APPEAL SUMMARY

Appeal ID: 15946	Project Address: 1325 NW Flanders St
Hearing Date: 10/11/17	Appellant Name: Tom Jaleski
Case No.: B-012	Appellant Phone: 5034885651
Appeal Type: Building	Plans Examiner/Inspector: Catherine Heeb
Project Type: commercial	Stories: 3 Occupancy: B, R-3 Construction Type: V-B
Building/Business Name: Armour Building	Fire Sprinklers: Yes - Basement, Exit Stair Enclosures
Appeal Involves: Alteration of an existing structure	LUR or Permit Application No.: 17-170180-CO
Plan Submitted Option: pdf [File 1]	Proposed use: Office and Residential

ARMOUR BLDG.
BASEMENT
RENOVATION

PROPOSED
BASEMENT FLOOR
PLAN

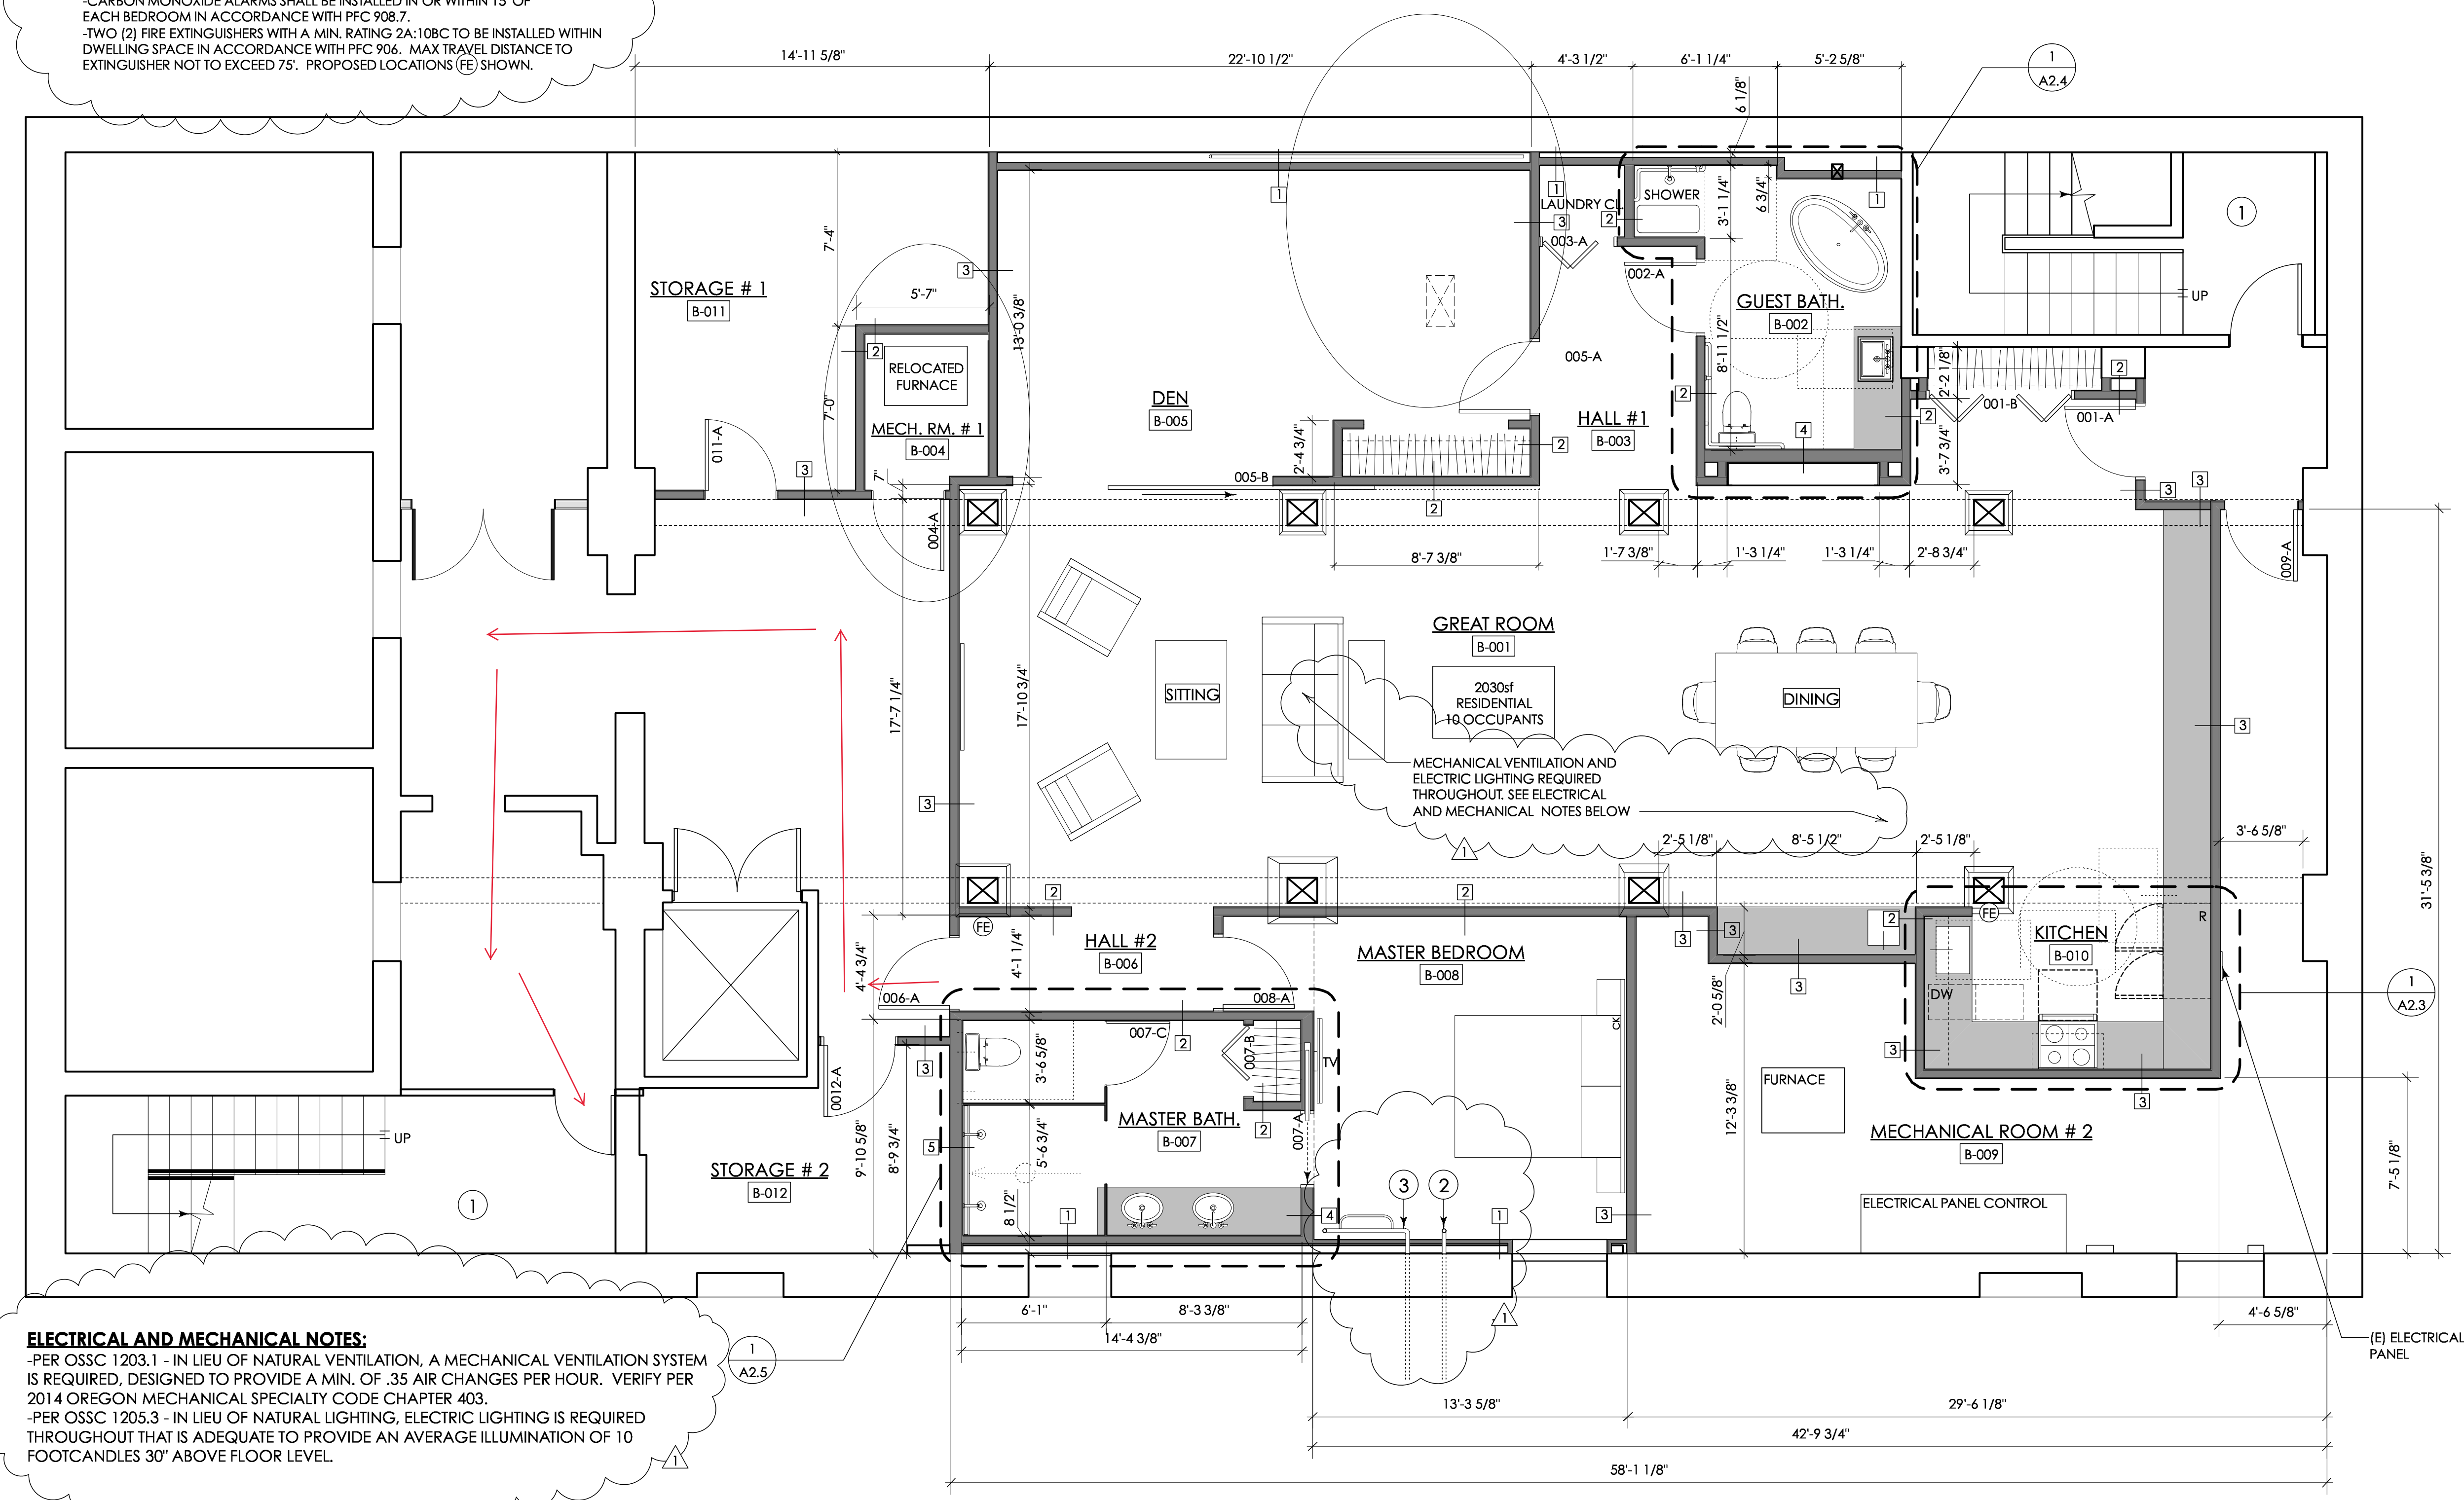
Proposed Design The proposed renovation includes a change of occupancy of 1,967 SF of storage space in the basement level of the Armour Building to a Group R-3 dwelling unit. The proposed design will include new partition walls, bathrooms, a great room, a kitchen, a den, and a bedroom.

The unit meets the requirements for Group R-3 occupancy except no emergency escape window will be provided. To provide equivalent protection, 2 means of egress will be provided where 1 is required, and the following additional protection measures will be included:

- Dwelling unit and 1 egress route 1-hour separated from adjacent areas in the basement.
- Dwelling unit 1-hour separated from Level 1.
- Basement and exit way fully sprinklered with an NFPA 13 system installed per OSSC 903.3.1.1.
- Sprinklers added within each of the 2 exit stair enclosures.
- Floor-level exit signs meeting the Group R-1 requirements of OSSC Section 1011.2.
- Smoke alarms interconnected within the basement.

This appeal proposes to use access to two exits in lieu of a single exit and an emergency escape in this Group R-3 unit, similar to the precedent set by R-2 requirements. One means of egress is required from the new R-3 basement dwelling unit per OSSC Section 1021.2, Exception 2.

Emergency escape is required in Group R-2 occupancies that have access to a single exit. A Group R-2 with access to more than one exit is not required to have emergency escape. The two full means of egress from the unit provide additional protection over providing one means of egress and an escape window.

1. Omission of emergency escape and rescue opening: Denied. Proposal does not provide equivalent Life Safety Protection.
